# TLE826xE/-2E

Universal System Basis Chip Family

## Errata Sheet

Rev. 1.00, 2012-02-28

**Figure 1 LH Activation during SBC Sleep Mode Not Permitted**

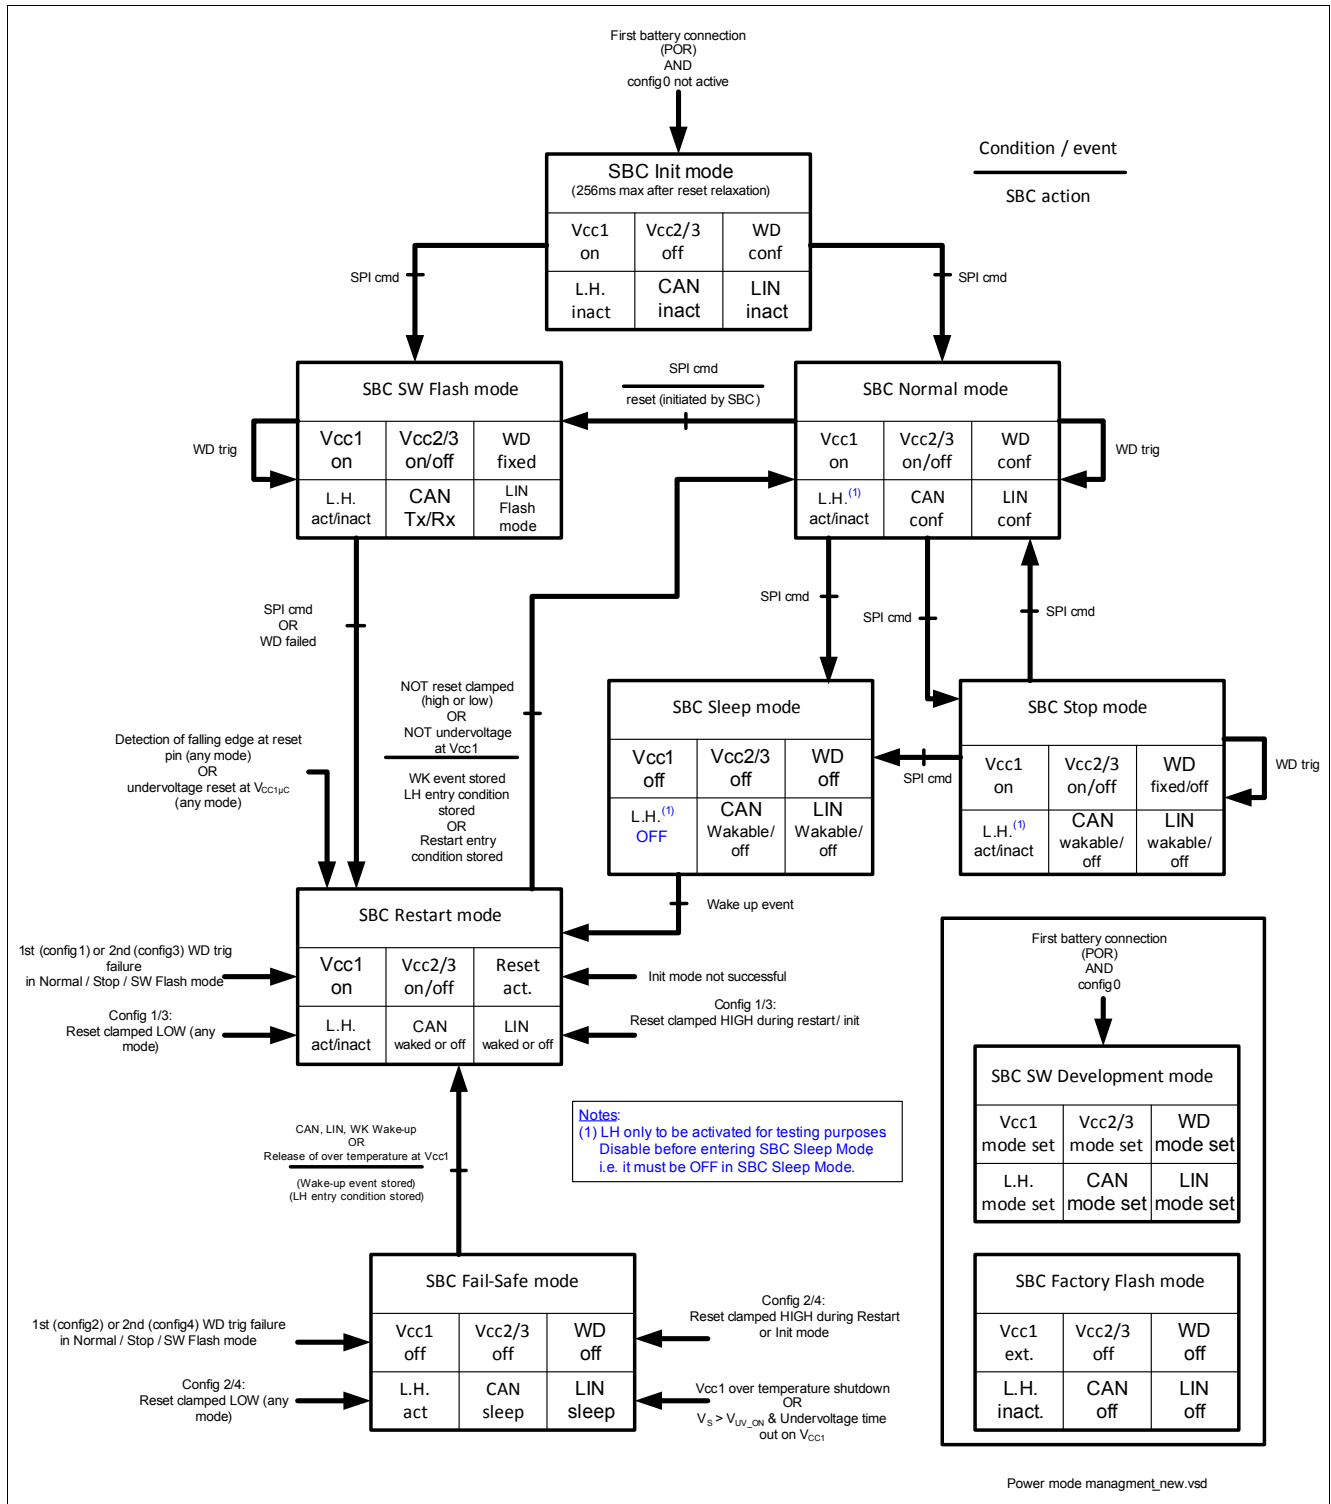
- $V_{cc1\_uC}$  undervoltage (UV) comparator can generate the chip-internal signal “no Vcc1\_UV” during SBC Sleep Mode after ~4 min
- Digital logic interprets  $V_{cc1\_uC}$  is enabled and reset output RO is internally set to “HIGH” after reset delay time (only occurs when Limp Home is activated)
- RO driver is not supplied ( $V_{cc1\_uC}$  is off in SBC Sleep Mode) → “Reset clamped low” (LH[2:0] = 110<sub>B</sub>) detected

- SBC detects failure and changes to SBC Restart Mode and switches on  $V_{cc1\_uC}$ , leading to SBC Normal Mode
- LH[2:0] shows 110<sub>B</sub> (“Reset clamped”) instead of 000<sub>B</sub>  
MS[2:0] shows 001<sub>B</sub> (coming from SBC Restart Mode) instead of 100<sub>B</sub> (coming from SBC Sleep Mode)  
RM[1:0] shows 01<sub>B</sub> (“Undervoltage on  $V_{cc1\_uC}$ ”) instead of 00<sub>B</sub>

- Do not activate LH before entering the SBC Sleep Mode (see also [Figure 1](#))
- Ensure that LH is disabled before entering SBC Sleep Mode, e.g. after a failure:
  - Check if the LH bit (bit 12 in the SBC Configuration Register CS[2:0] = 100<sub>B</sub>) is set
  - If the LH bit is set, then send a valid watchdog trigger. Otherwise the SBC can be sent to Sleep Mode immediately.
  - Disable the LH bit (*Note: this must be a separate SPI command*)

*Note: LH will be activated automatically due to a failure during the device operation and is not automatically disabled when entering SBC Normal Mode. Therefore, it must be ensured that LH is disabled before entering SBC Sleep Mode.*

**Figure 2** Verifying actual device status after coming from SBC Sleep or Fail-Safe Mode

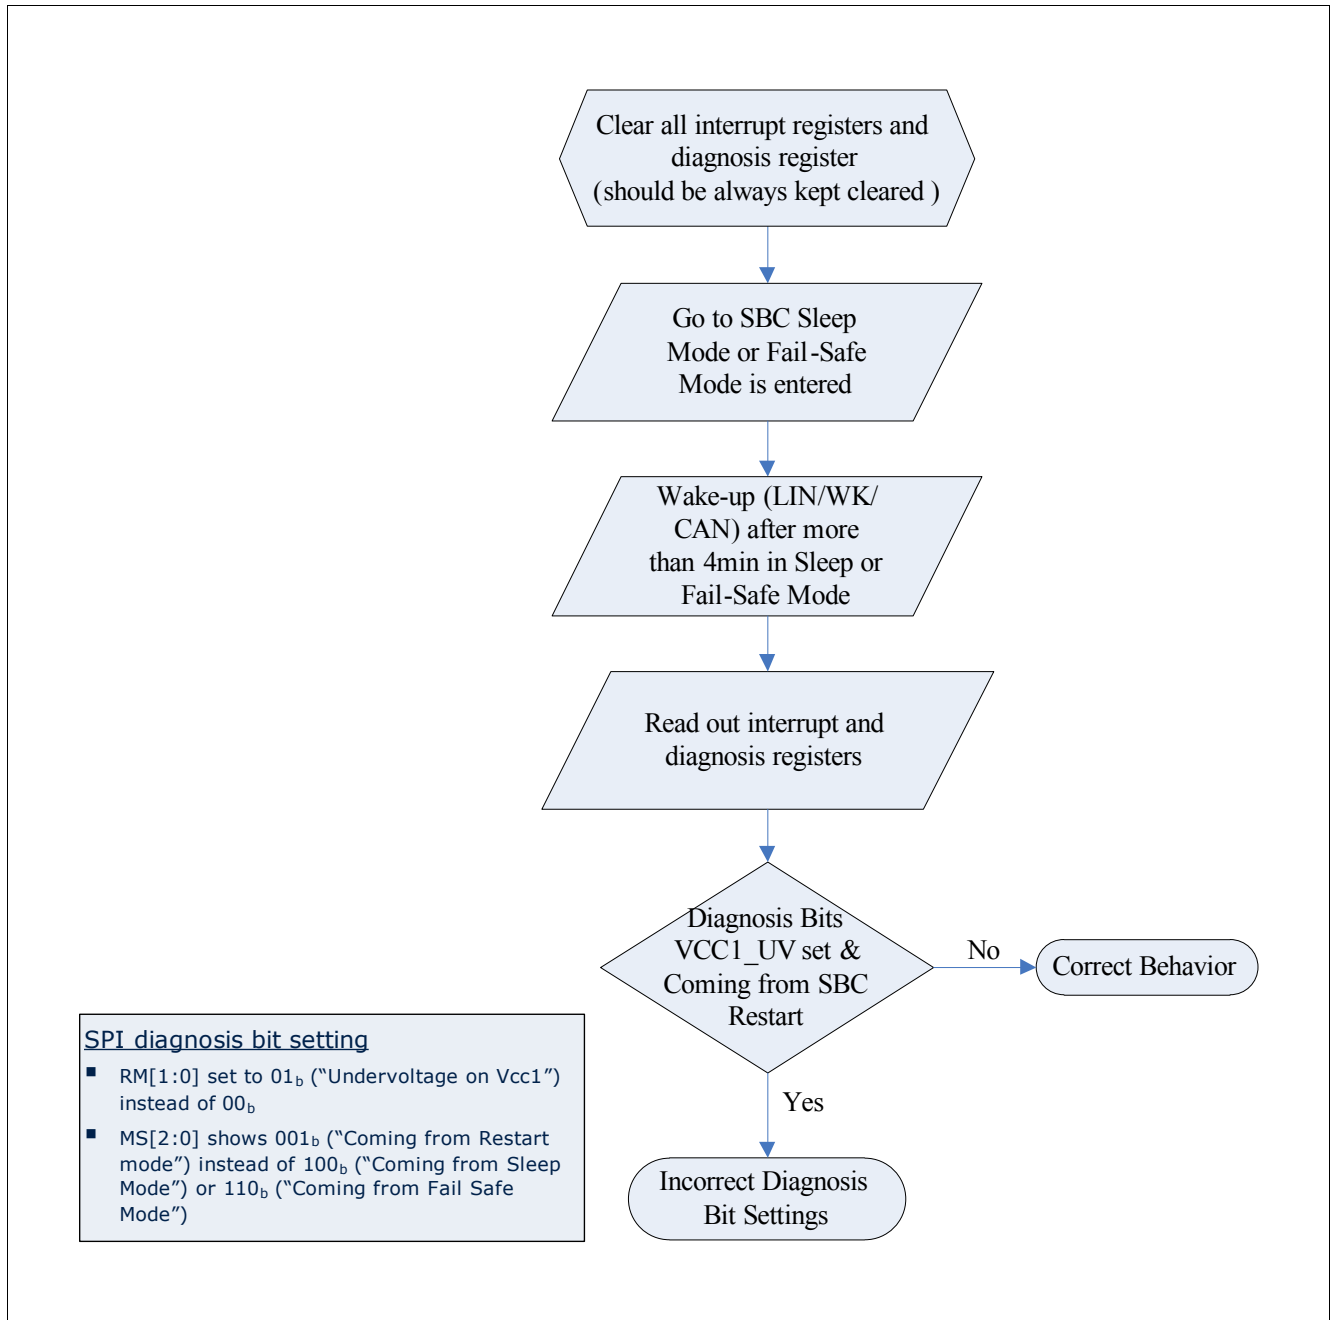
- $V_{cc1\_uC}$  undervoltage (UV) comparator generates the chip-internal signal "no Vcc1\_UV" during SBC Sleep or Fail-Safe Mode (see also [Chapter 2.1](#)) but device will only wake up by an external wake-up event on CAN, LIN or WK as defined in the datasheet.
- At the SBC mode transition from SBC Sleep or Fail-Safe Mode to Restart Mode  $V_{cc1\_uC}$  is enabled and  $V_{cc1\_uC}$  UV comparator shows correct signal "Vcc1\_UV". This transition from "no Vcc1\_UV" to "Vcc1\_UV" causes an unexpected failure signaling and the SPI bits RM[1:0] set to 01<sub>B</sub>.

- RM[1:0] set to 01<sub>B</sub> ("Undervoltage on  $V_{cc1\_uC}$ ") instead of 00<sub>B</sub>
- MS[2:0] shows 001<sub>B</sub> ("Coming from Restart Mode") instead of 100<sub>B</sub> ("Coming from Sleep Mode") or 110<sub>B</sub> ("Coming from Fail-Safe Mode") respectively

- Always clear interrupt and diagnosis (Limp Home) registers before entering SBC Sleep Mode
- Save last SBC State in microcontroller, e.g. SBC was sent to SBC Sleep Mode
- Read out interrupt and diagnosis (Limp Home) registers after wake-up (see [Figure 2](#))

Figure 4 Missing reset delay time after coming from SBC Reset Mode

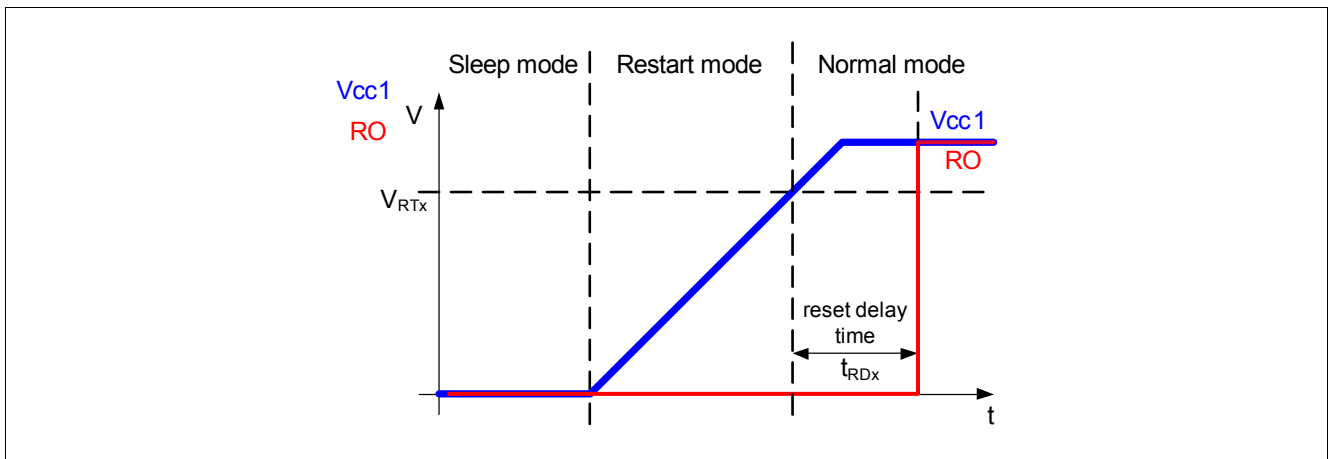
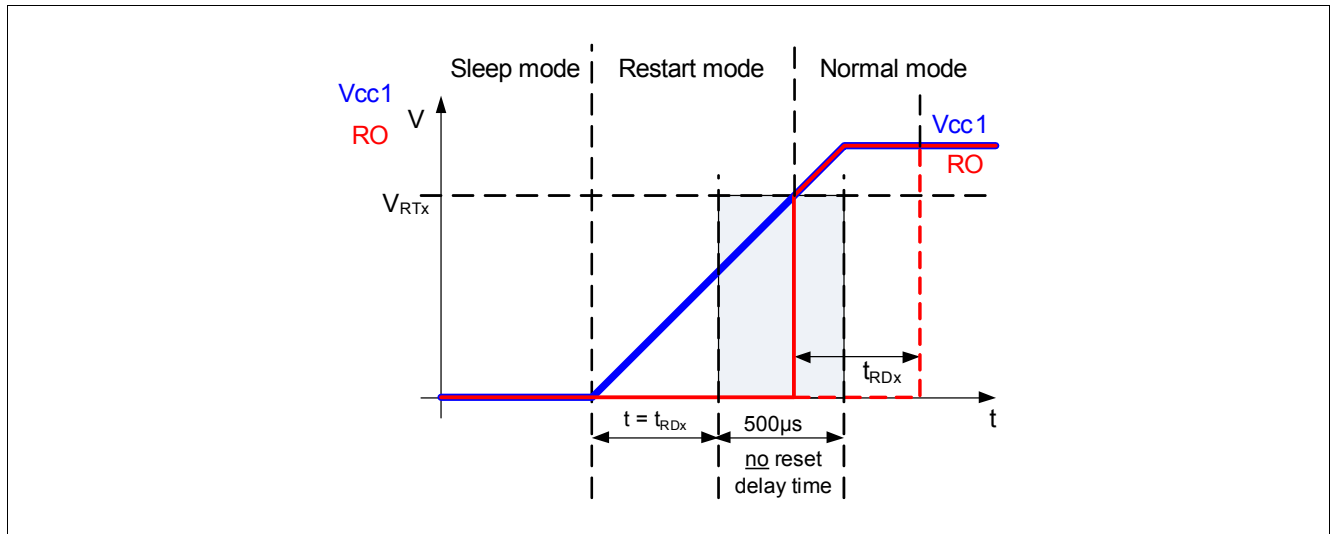
- Under conditions as described in [Chapter 3.1](#) no reset delay time will be triggered. See also [Figure 4](#)
- When  $V_{cc1\_μC}$  is ramping during SBC Restart Mode an internal counter starts running to test for the “Vcc1 undervoltage time-out” behavior. However, the same counter is used for the reset delay time  $t_{RDx}$ . See also [Chapter 3.3](#)

- When the counter content shows the end of the reset delay time when  $V_{cc1\_μC}$  is crossing the  $V_{RTx}$  threshold, RO is set to "HIGH" already after 10μs (typ) instead of configured  $t_{RDx}$

- The critical range in time (see Figure 4) is the period between  $t_{RDx}$  and  $t_{RDx} + 500 \mu s$
- When  $V_{cc1\_μC}$  exceeds  $V_{RTx}$  during that time, the reset delay time is skipped and RO is release already after 10μs (typ.)
- The critical range for the external capacitor at  $V_{cc1\_μC}$  and  $t_{RD2}$  selected can be calculated (assuming the capacitor is discharged):

- Select the long (default) reset delay time  $t_{RD1}$  (in that case  $C_{crit} > 185 \mu F$ ). Changing the reset delay time does not affect any other behavior of the SBC.
- The selected reset threshold  $V_{RTx}$  has a small influence only

**Figure 5** Simplified timing diagram (not to scale) of a dominant CAN bus signal longer than  $t_{\text{BUS\_TO, max}}$   
The SPI CAN Fail Bit is set

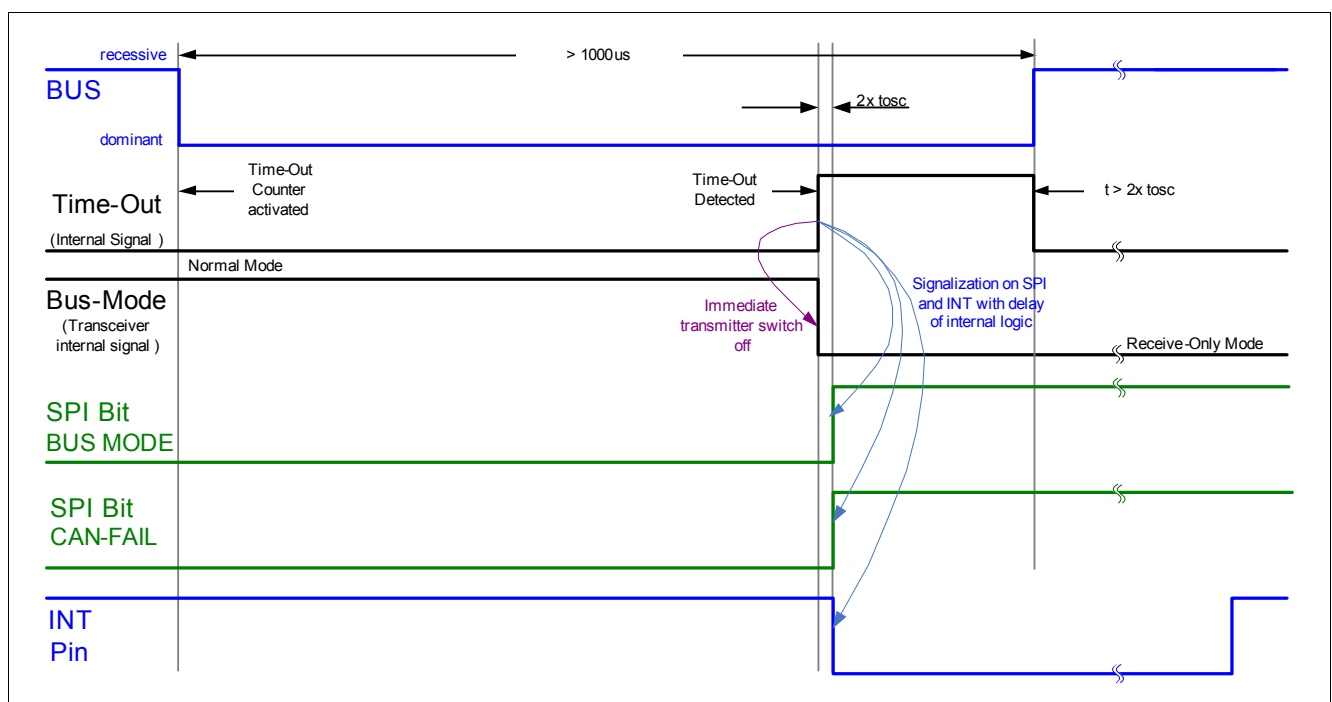
The SPI bus failure bits are set accordingly if the detected time-out condition is valid for a sufficient time ( $>2$  clock cycles  $\approx 8\mu\text{s}$ ). As shown in **Figure 5**, this is the case if the dominant time-out condition is valid longer than the maximum time-out detection period  $t_{\text{BUS\_TO}}$ .

**Figure 6** Simplified timing diagram (not to scale) of a dominant CAN bus signal in the range of 300 -600us. No SPI CAN fail bit is set

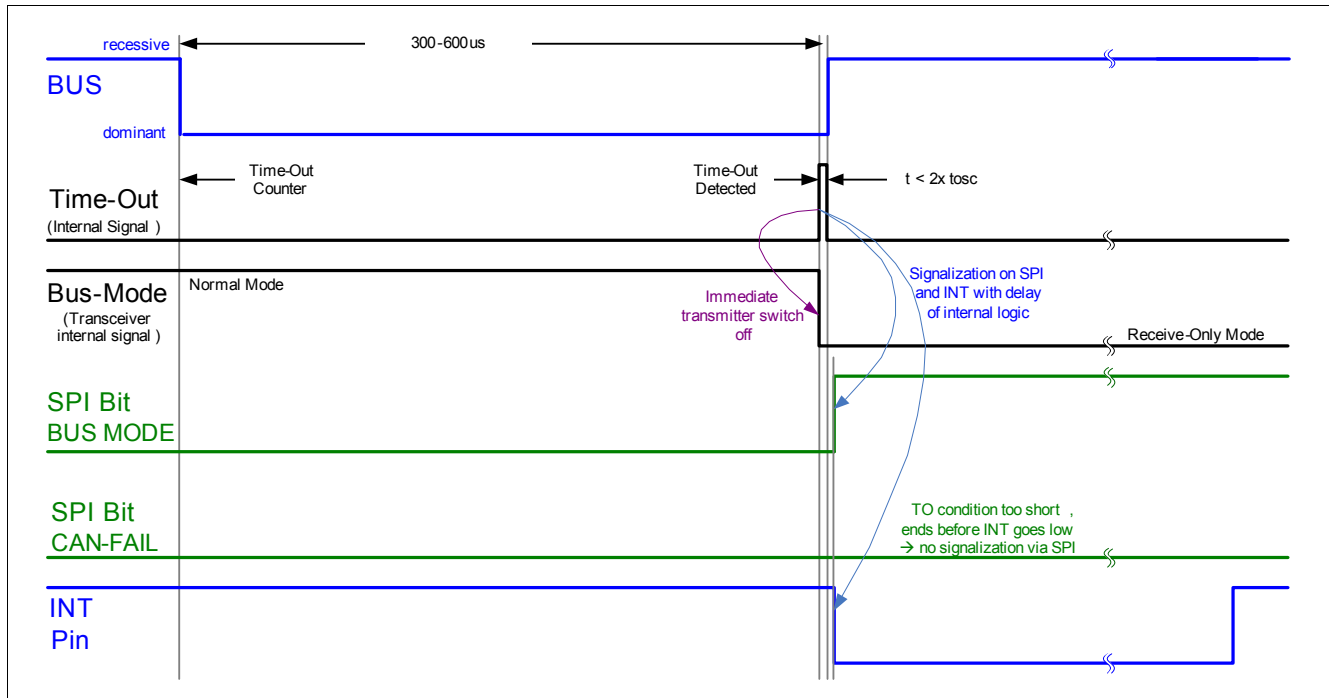
If the time-out condition disappears shortly after the detection (1-2 clock cycles) it is possible that the SBC will capture the time-out event but not set the corresponding SPI flag. The INT pin is properly toggled, the transceiver is properly set into Receive Only Mode. However the SPI flag is not set. This behavior will occur for dominant CAN signals within the range of 300 $\mu\text{s}$  and 600 $\mu\text{s}$  (for LIN signals between 10ms and 14ms). A timing diagram showing this behavior is shown in **Figure 6**.

This behavior will also be seen when the transceiver is switched again to Normal Mode (from Receive Only Mode) during the dominant pulse and when the remaining dominant period falls within the above mentioned range.

- Read the status of the communication setup register (101) to check if the transceivers have changed modes (i.e. from Normal to Receive Only Mode).
- If this is the case, then a bus failure has occurred and the microcontroller must switch the transceiver back to normal mode if applicable.
- If the mode of the transceivers is unchanged, then another ghost interrupt has occurred caused by a register read out while INT was HIGH (not a bus dominant time-out). If the interrupt registers are all '0', then the INT trigger should be ignored by the software.
